Access Compliance Report

Public Rights-of-Way

(Curb Ramps)

Intersection ID: 13541	Main Street: CENTRAL_AV	Cross Street: EASTCREST_DR	Location: SE
ADA ID: E43F741B730B	Ramp Type: Perp	Initial Pass/Fail: Fail	Overall Compliance: No
Codes/Mitigation Info/Possible Solution			Severity Score: 10
			Field Measurements/Component Compliance

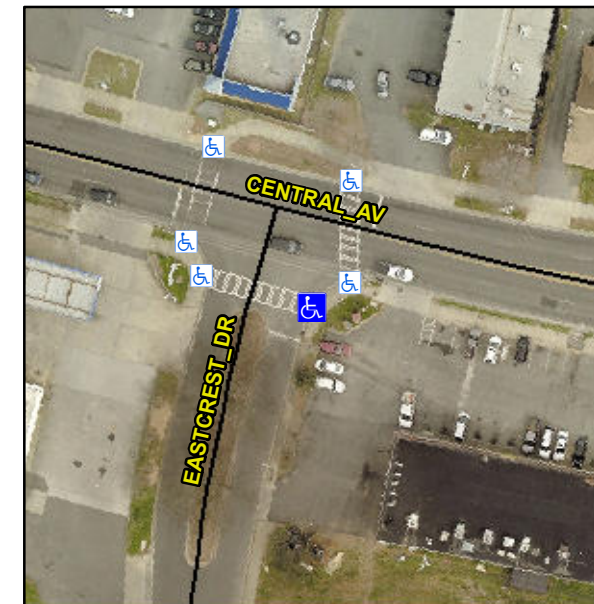
Not Found, R304.5.1, R304.5.3

Remove & Replace Entire Ramp.
